Bent Grass East Commercial Filing No. 3 Traffic Impact Analysis

LSC #204660

LSC Responses to TIS Redline Comments on.. Bent Grass Commercial Update TIA REPORT

Figure 3

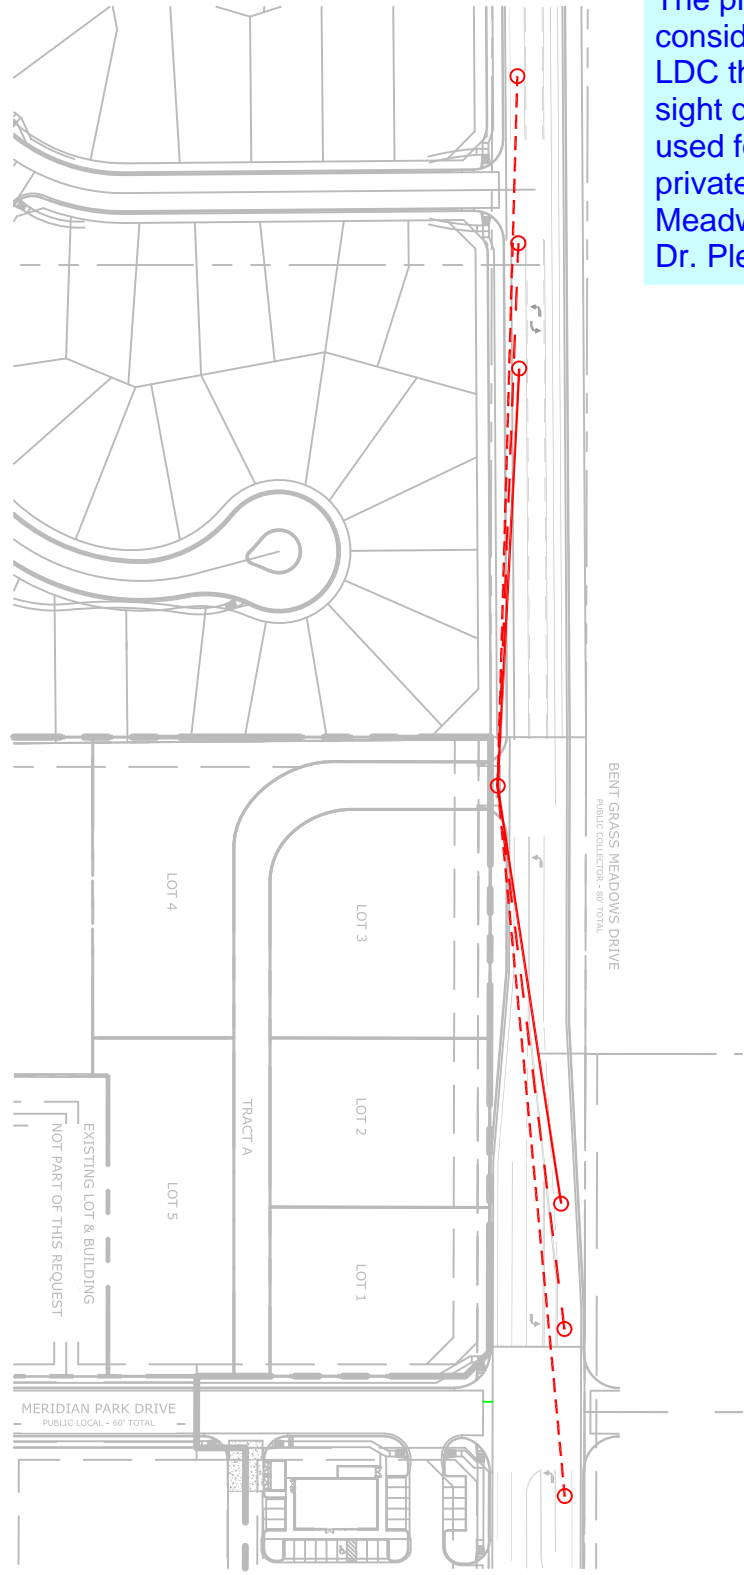
The proposed private drive is considered a roadway per the LDC therefore the intersection sight distance criteria should be used for the intersection of the private road to Bent Grass Meadows Dr and Meridian Park Dr. Please revise accordingly.

The proposed private drive is considered a roadway per the LDC therefore the intersection sight distance criteria should be used for the intersection of the private road to Bent Grass Meadows Dr and Meridian Park Dr. Please revise accordingly.

The analysis has been revised as requested

Figure 5

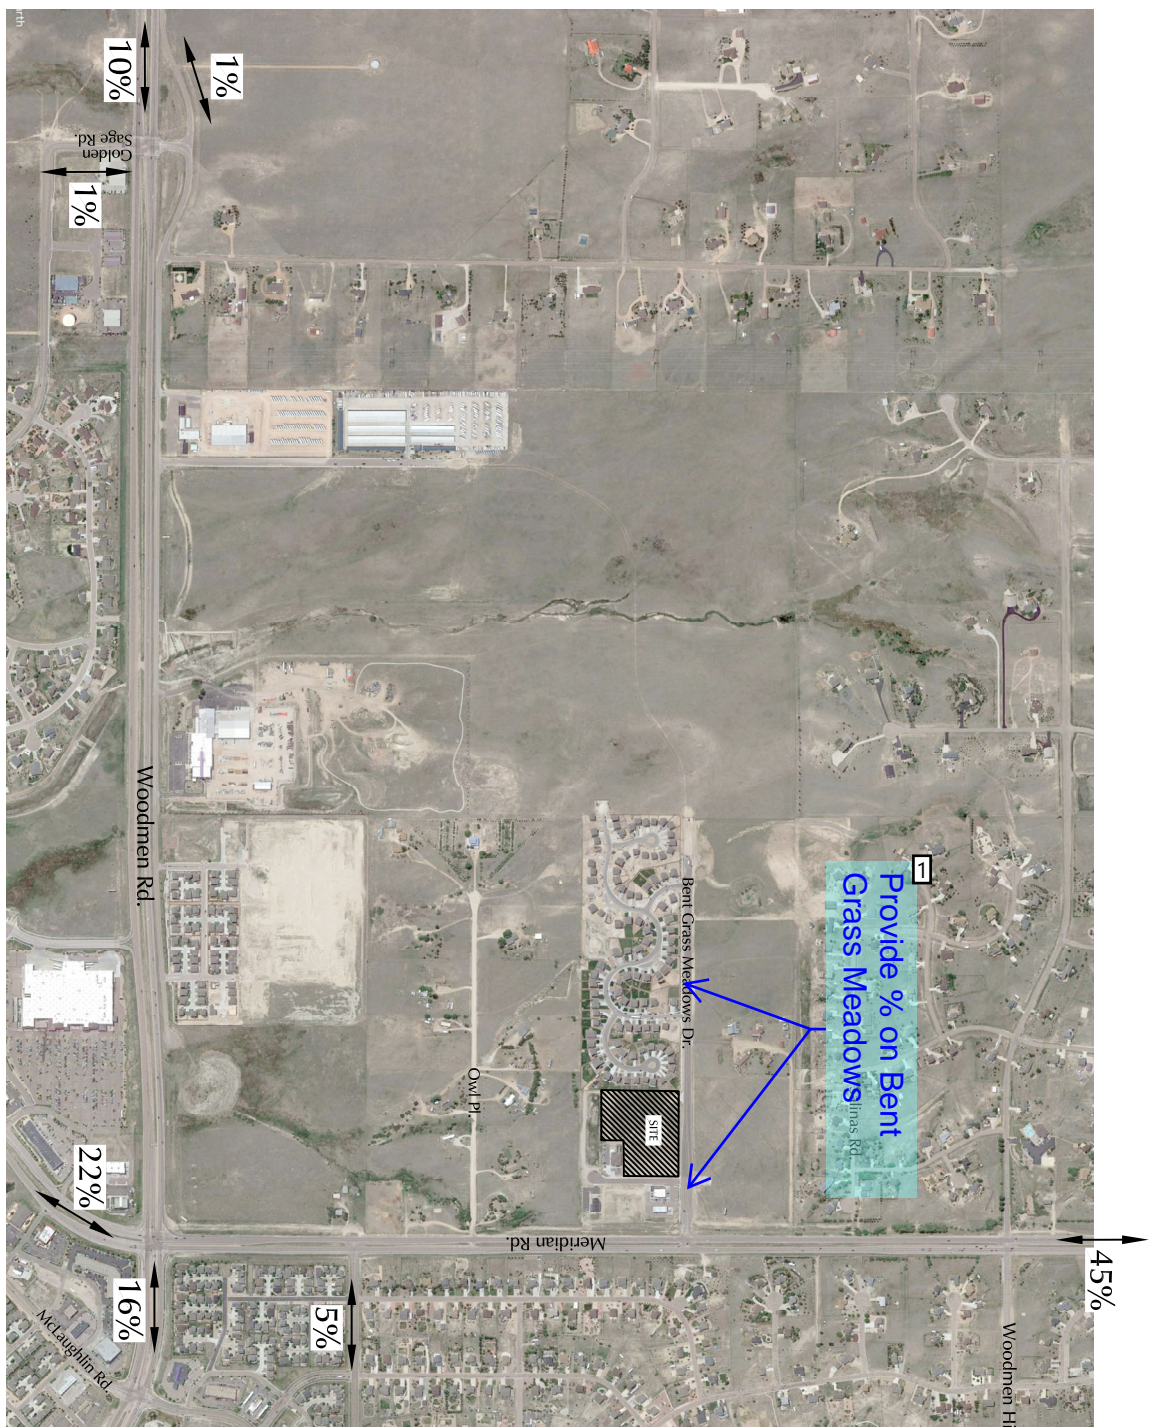
[Please see comment in figure 5.](#)

Per the Falcon Meadows PUDSP traffic study it appears that traffic counts were also conducted in December 2020. Please also include these or any other more current studies in your analysis.

LSC Response: The most current count data has been included in the updated TIS as requested.

LSC Response: The more current counts have been included as requested

Figure 8

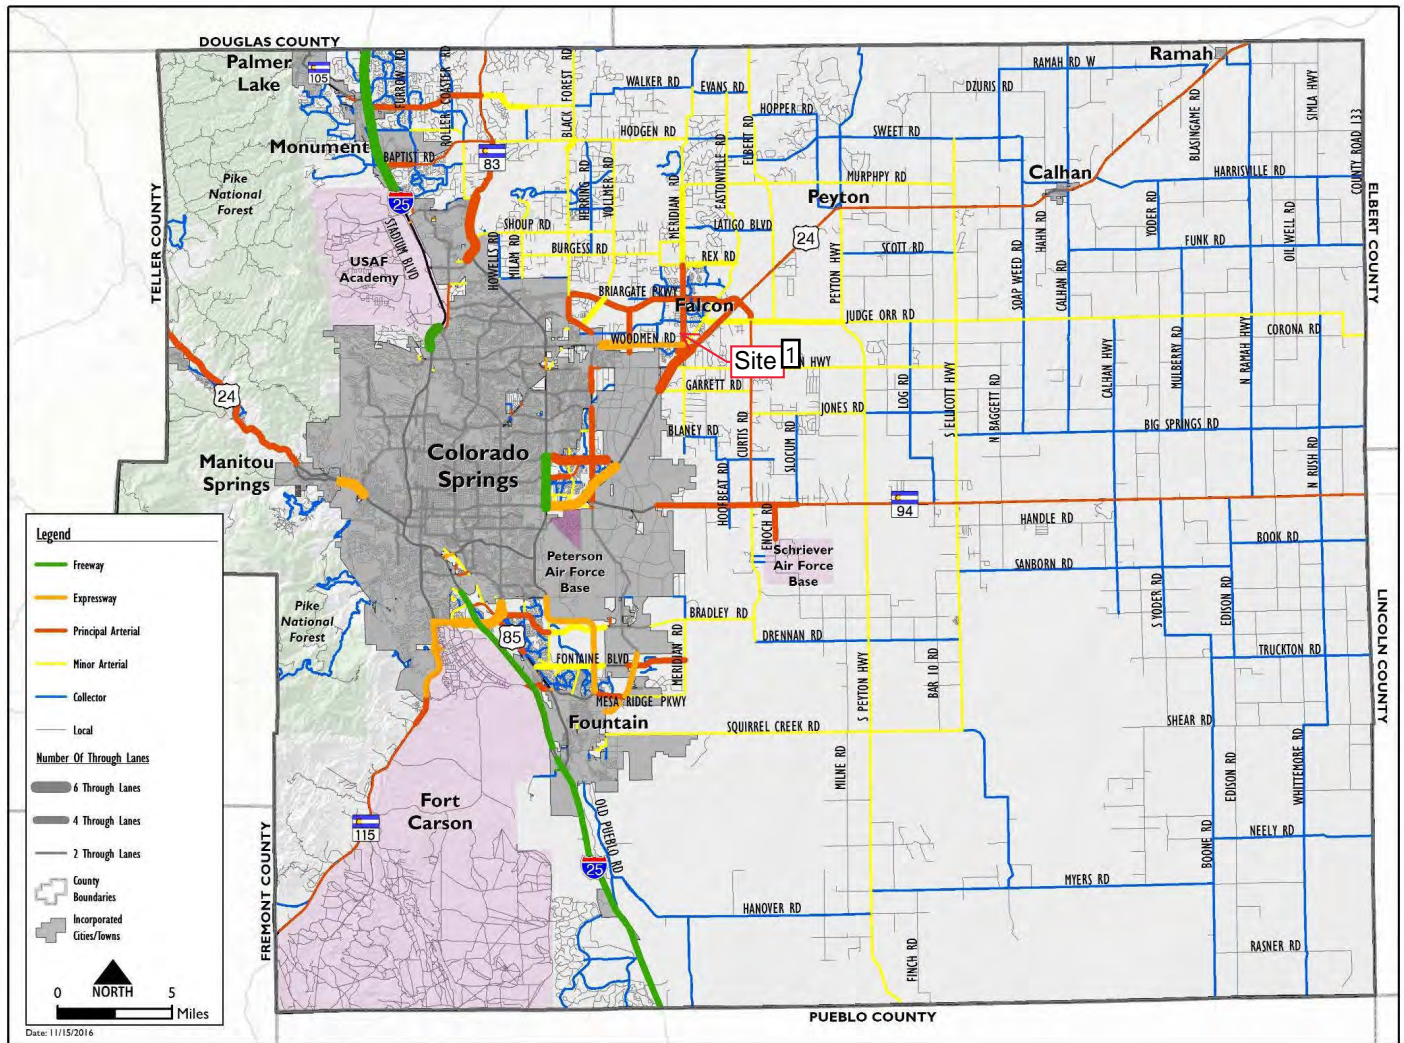
[Provide % on Bent Grass Meadows](#)

LSC Response: The additional information has been included in the updated TIS as requested
